LAX Community Noise Roundtable

Work Program A1

Review of SoCal Metroplex Proposed Procedures
and Suggestions for Comment Letter

July 8, 2015

**LAX CRSHR STAR
Replaces KEACH
STAR**

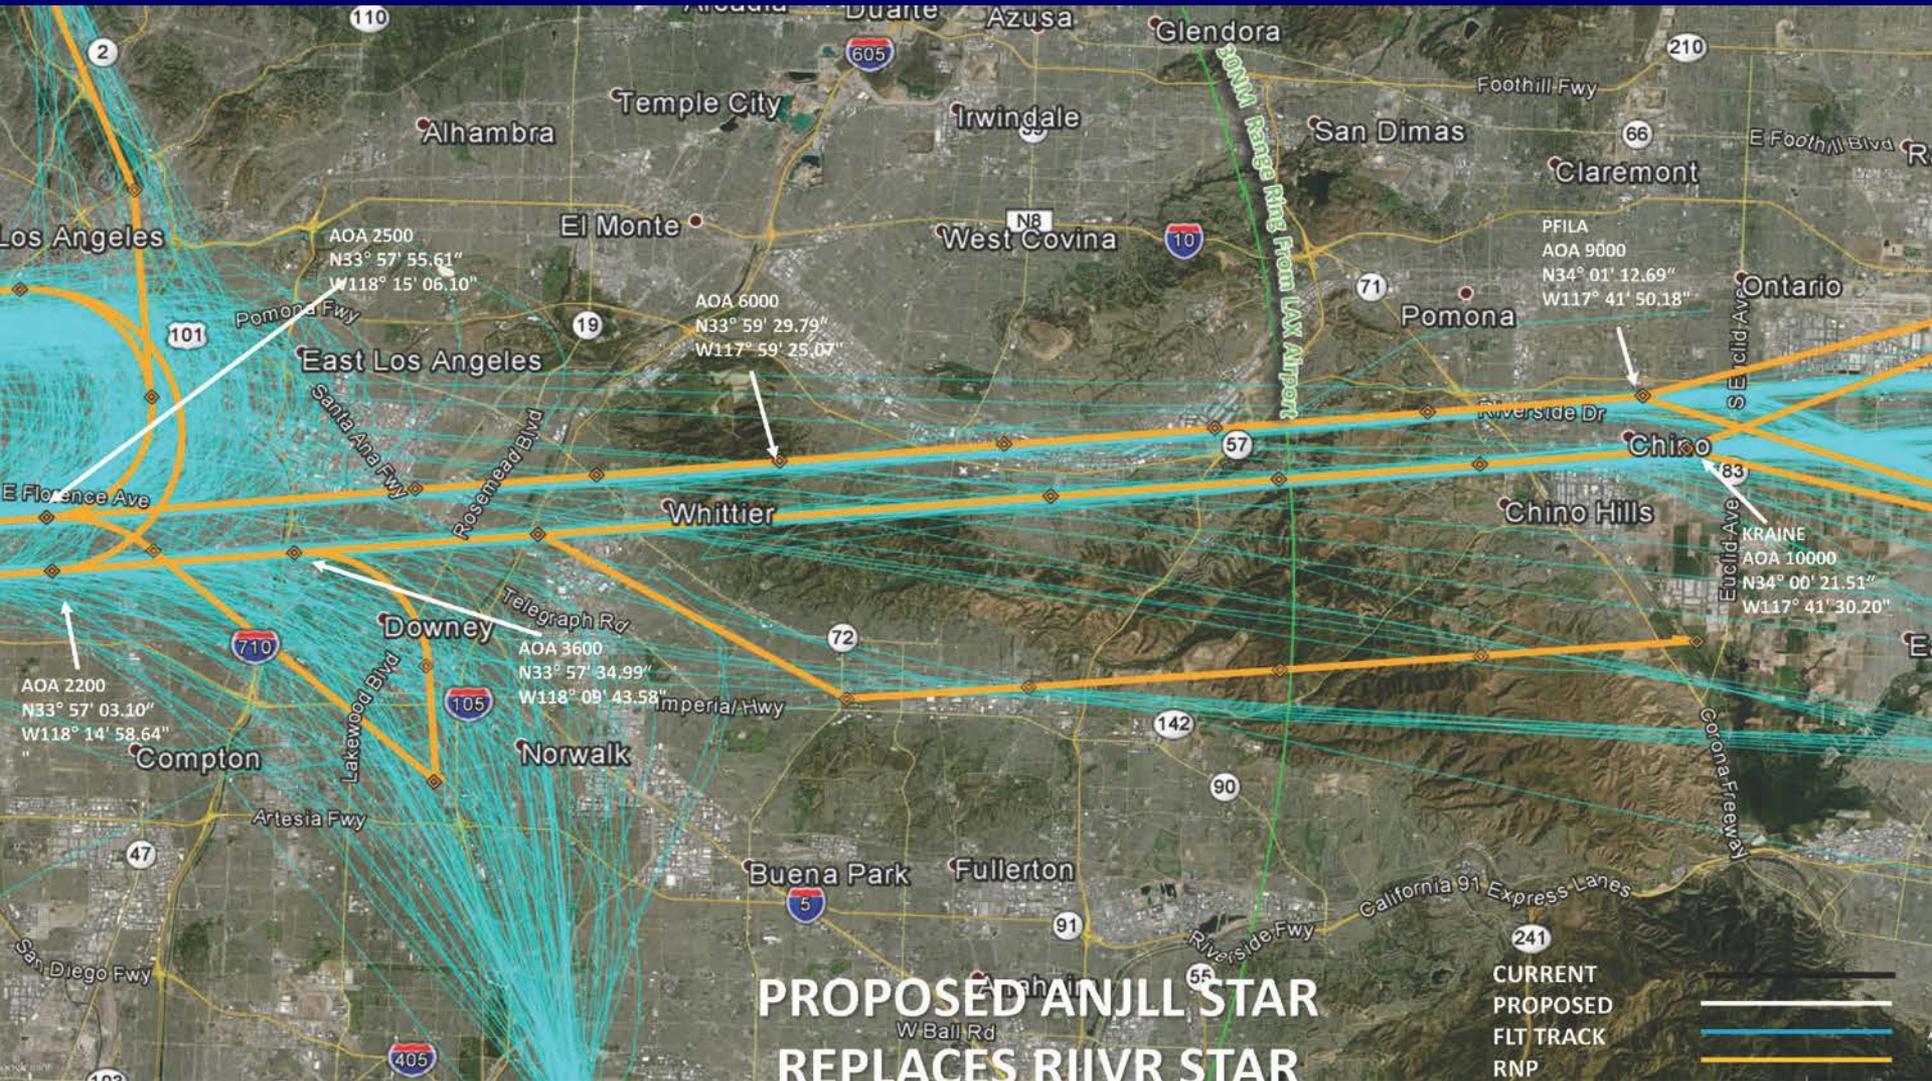
- 1) Increase the minimum altitude as much as possible for aircraft on the extended downwind and base legs of the approach to reduce noise**
- 2) Explore options to reduce the requirement of using the extended downwind approach as a way to minimize Monterey Park overflights**

- North Downwind RNP arrival procedures during west flow may partially reduce overflights of Monterey Park;**
- Approximately 40 percent of the aircraft using LAX can fly the RNP;**
- Concentrates the base leg turn over primarily commercial land uses between the 110 and 710 freeways;**
- Aircraft may still be vectored further to the east when safety requires it or aircraft are not equipped to fly the RNP**

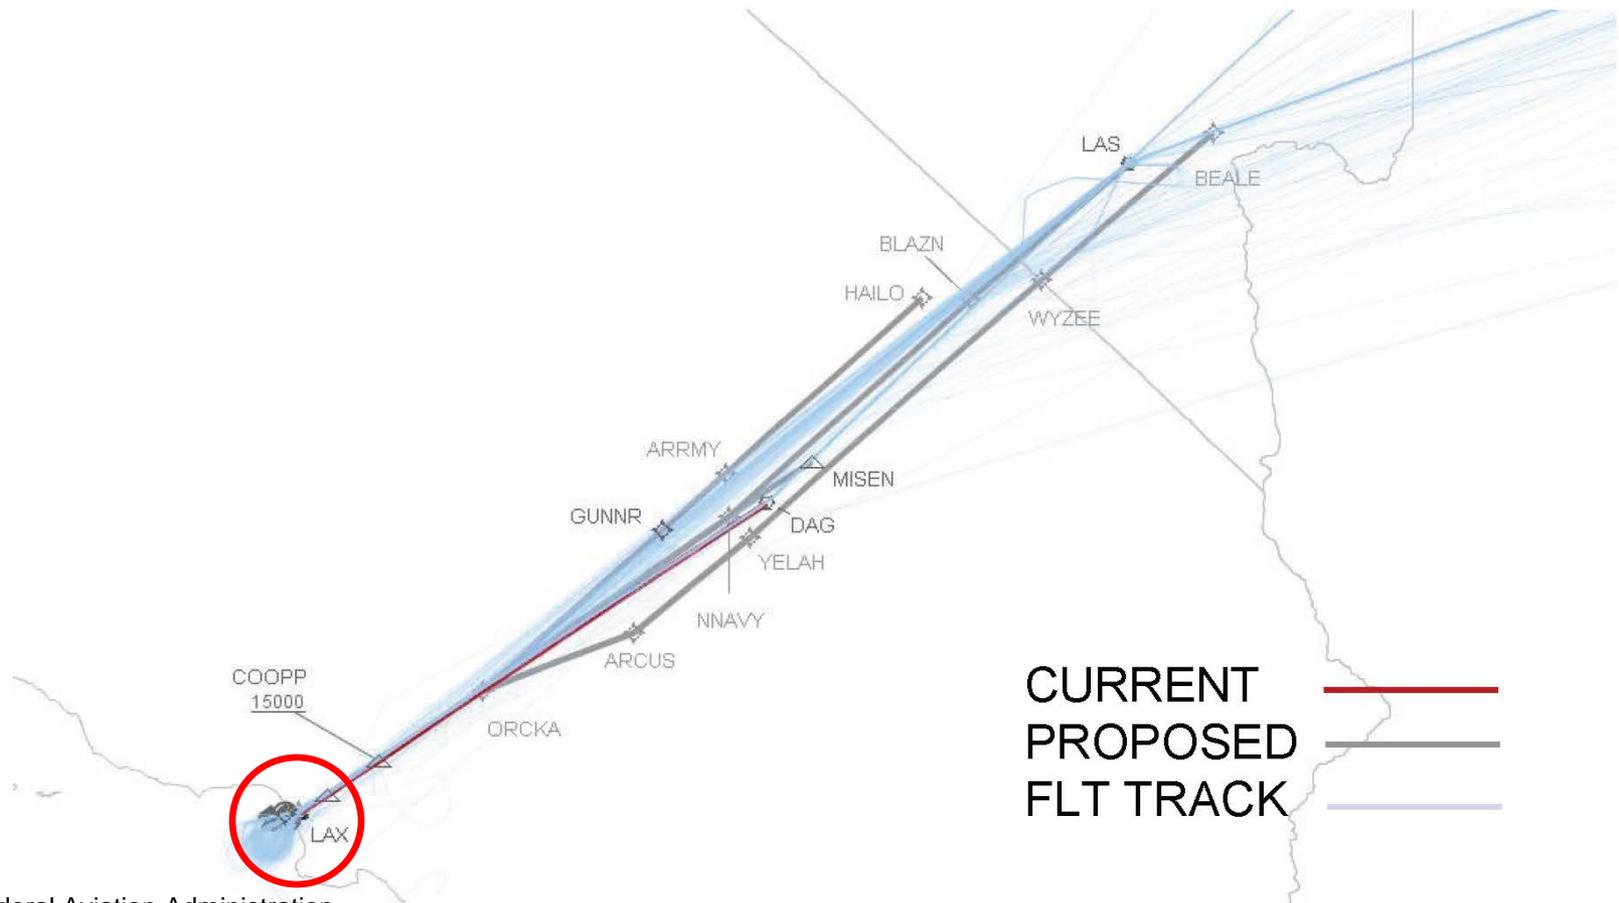
- 1) Re-investigate the possibility of increasing the altitudes for aircraft on the CDA**
- 2) Explore other possible solutions to resolve this issue.**

- Altitudes of new RNP arrival procedures remain the same as the conventional approach procedures;**
- The new RNP arrival tracks remain in similar locations as the conventional approach procedures;**
- The RNP arrival tracks will be more precise and concentrated than the conventional approach procedure tracks**

LAX LOOP8 SID West Flow (Old) LAX ORCKA1 SID Flow (New) *Wide view*

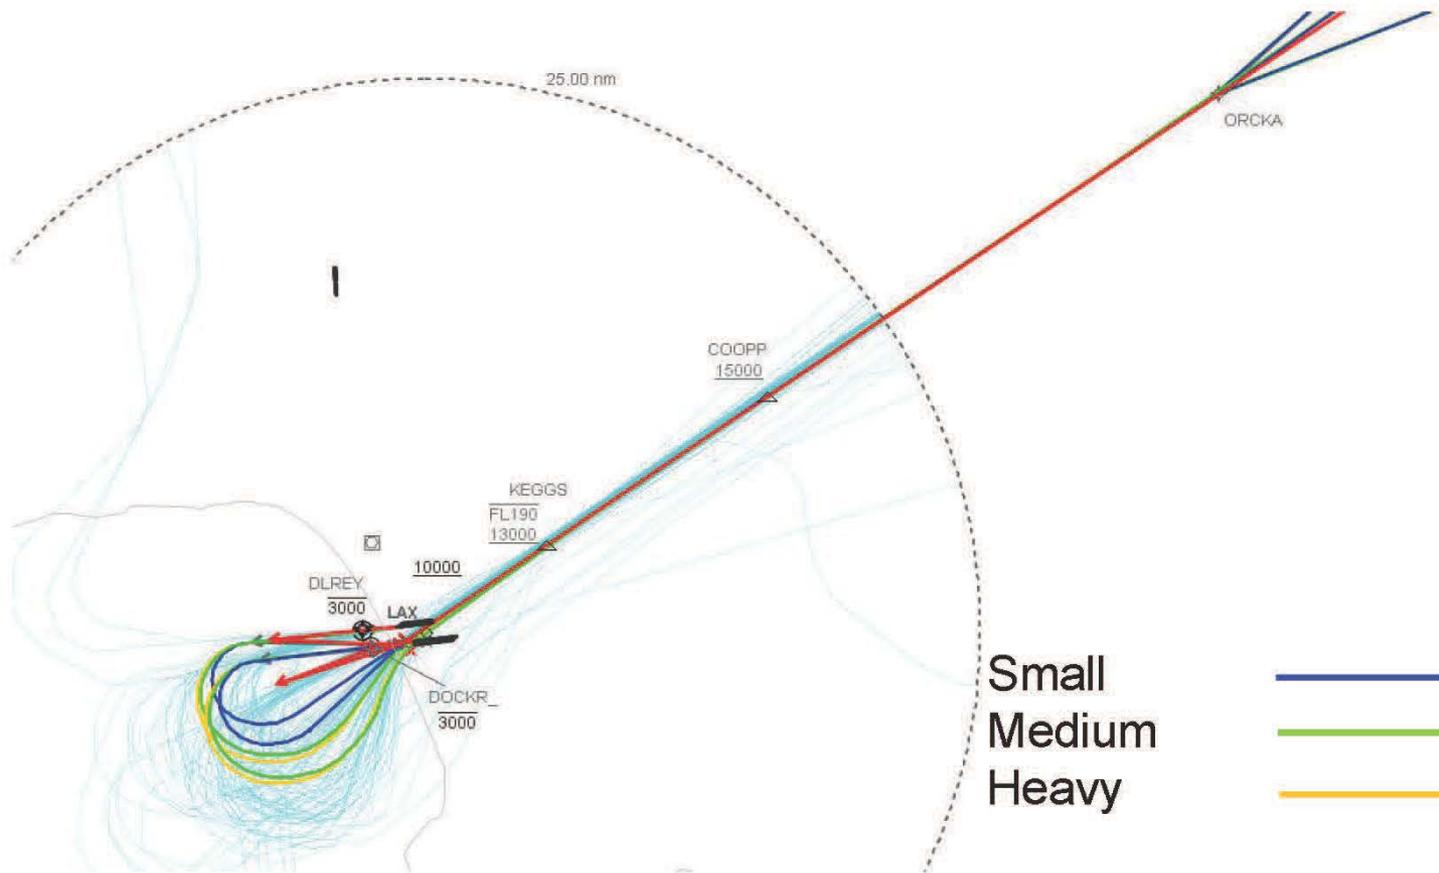
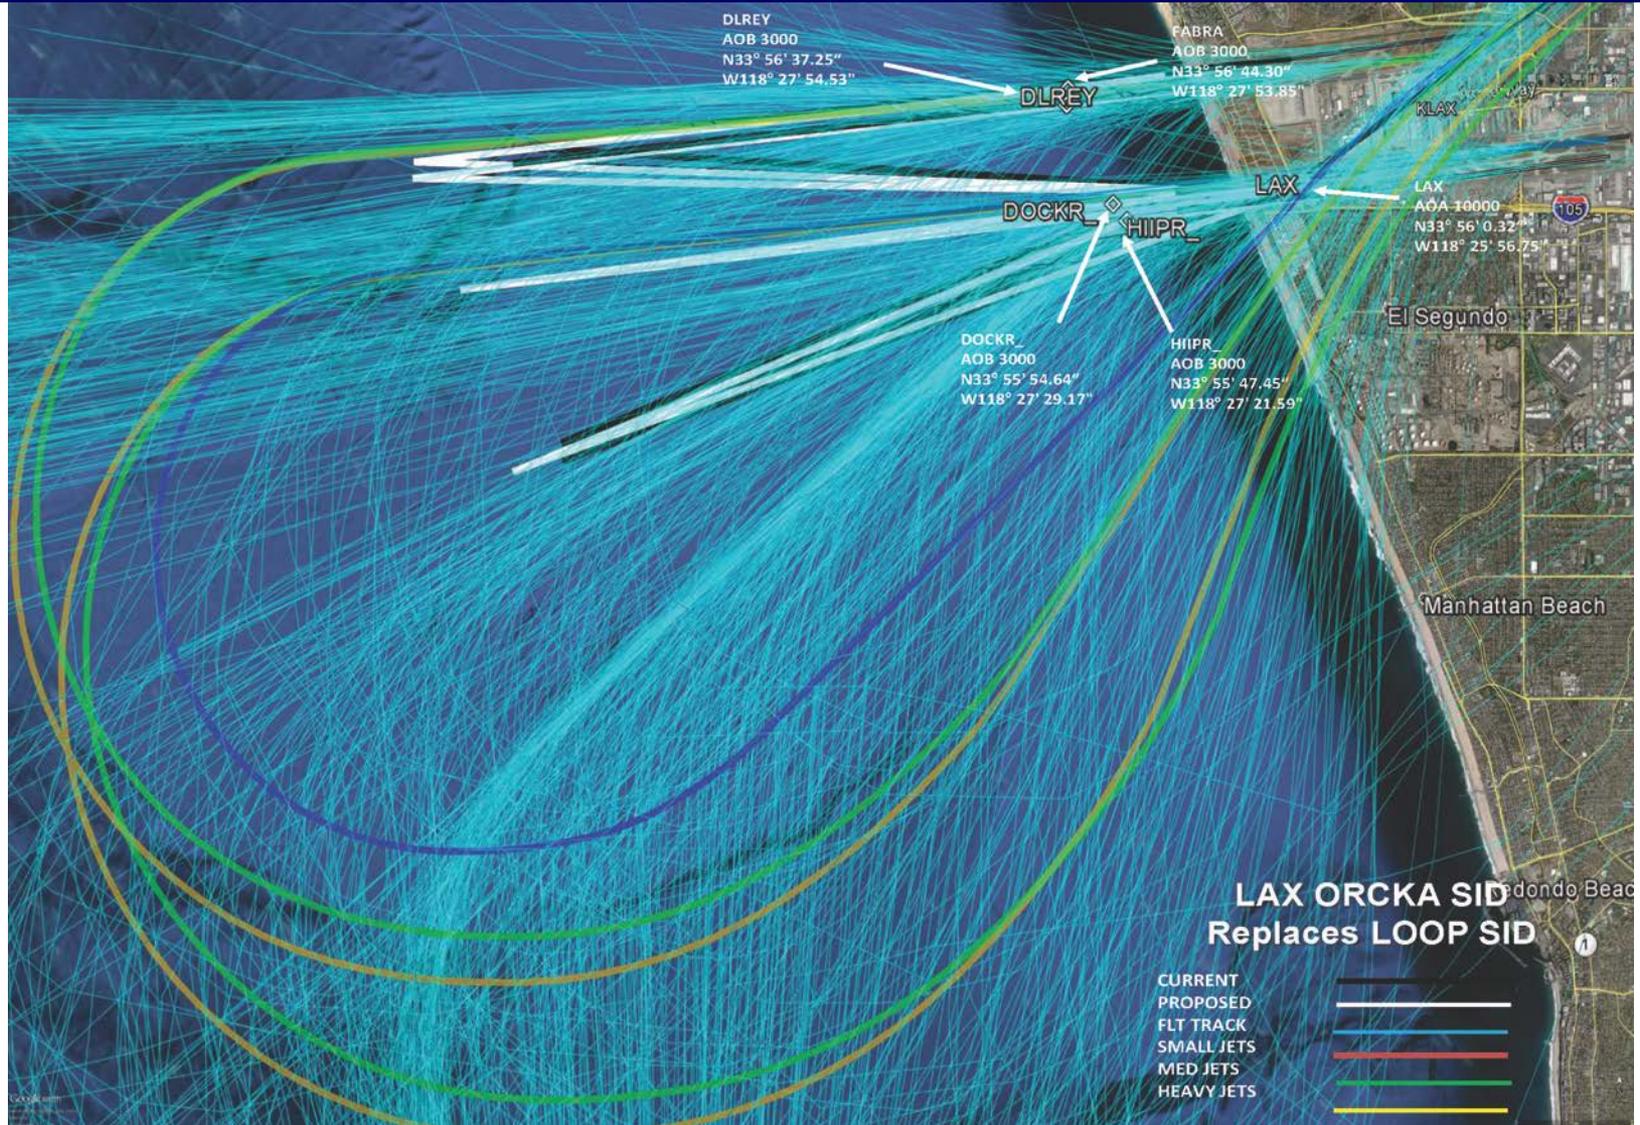
- 1) Re-investigate the possibility of establishing the LOOP RNAV/RNP procedure to help “tighten” the loop operations and**
- 2) Look into other possibilities to improve the compliance of the LOOP departure procedure through the FAA OAPM process**

- The ORCKA1 SID replaces the LOOP8 SID, but with no additional controls or waypoints to improve adherence of aircraft flying over LAX when re-crossing the shoreline;**
- The ORCKA1 SID provides three different routes well east of LAX to allow FAA to maintain efficiency across a mix of aircraft types;**
- The At Or Above (AOA) altitude near the LAX VOR remains at 10,000 feet**

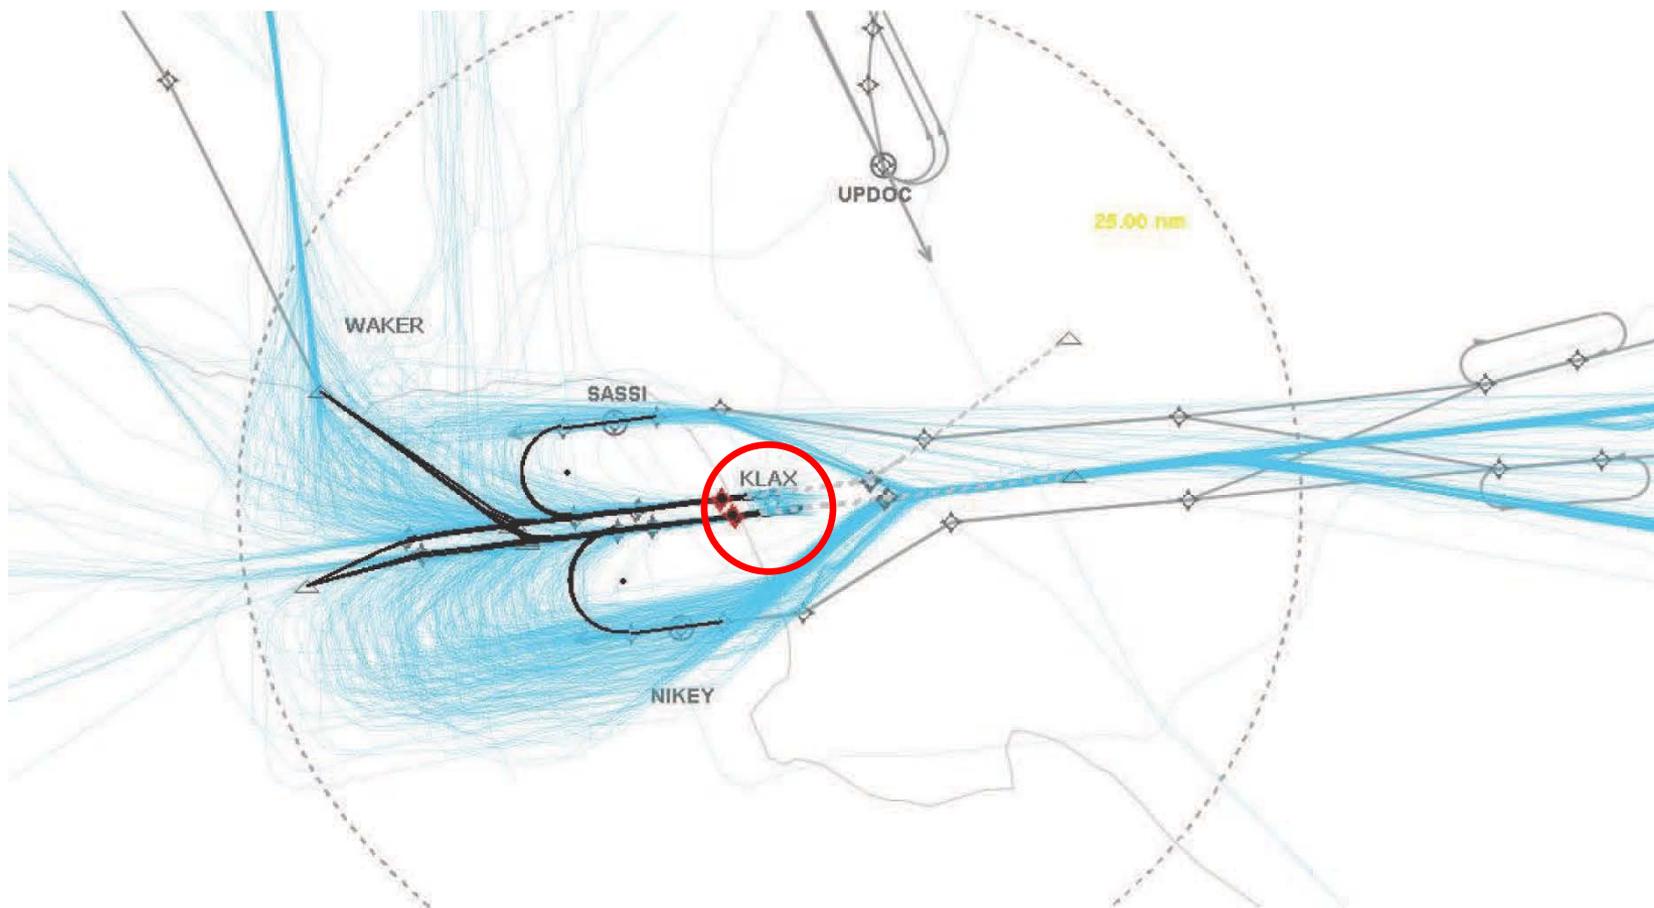
- 1) Explore options that could help pilots and controllers to reduce early turn operations and**
- 2) Explore the possibility of adding a waypoint in the RNAV procedures or use other emerging technologies to assist pilots in identifying the shoreline during IFR conditions that could in turn help reduce early turns**

- 1) Explore options of redesigning the JEDDD procedure that will meet all necessary requirements to allow full implementation of the procedure,**
- 2) Reroute the remaining turboprop aircraft that are currently overflying the Peninsula to offshores routes, and**
- 3) If option 2 proves infeasible, then increase the minimum altitude of turboprop aircraft that overfly the Peninsula**

- None of the new SIDs explicitly provide guidance to pilots to remain on runway heading until crossing the shoreline;**
- The waypoints of FABRA, DELRY, DOCKR, and HIPR retain 3,000-foot MSL At OR Below (AOB) altitude limits**

- The FAA did not propose any changes to the existing turboprop departure procedures at LAX as part of the Metroplex process**
- In November 2014, SkyWest announced a phase out of its turboprop operations at LAX, which should further reduce turboprop overflights of the Palos Verdes Peninsula**
- Current turboprop traffic volume at LAX is low**
